Mason Mt WMA- ADA Evaluation

Accessibility Evaluation

Inspection Date: 06/16/2022

Report Date: 01/17/2024

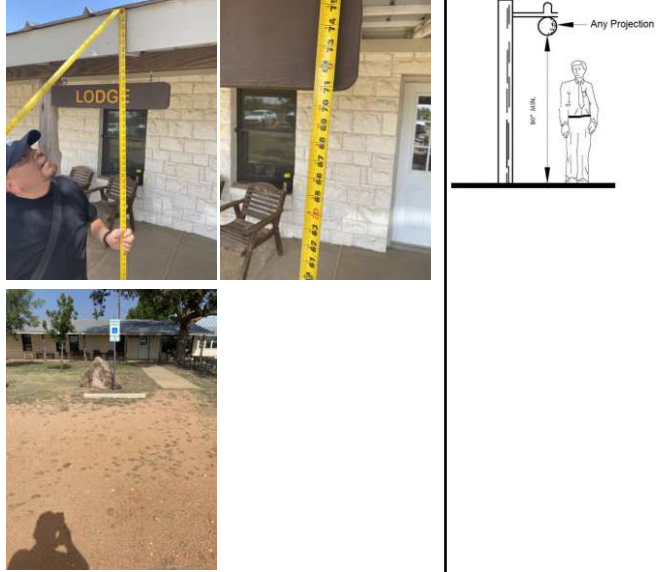
Finding Number	Area Description	Finding	As Built	Recommendation	Citation	Photos	Figure
1	Exterior of Property (Public): Lodge Parking Lot (2 Spaces) 2 Van	There are no accessible parking stalls. Each lot where parking is provided for the public as clients, guests or employees, shall provide accessible parking and shall be located on the shortest accessible route of travel from adjacent parking to an accessible entrance. There are a total of (XX) parking stalls in the parking lot that could be reasonably associated with this facility. There should be a minimum of (XX) accessible stalls with a minimum of (XX) being designed as van accessible.	Parking lot is not compliant due to surfacing material and striping requirements.	Review parking stall and access aisle requirements https://www.access-board.gov/ada/#ada-208_2 https://www.access-board.gov/ada/#ada-502	2012 TAS Section: 208.2 2010 ADAS Section: 208.2 2015 ABAAS Section: F208.2
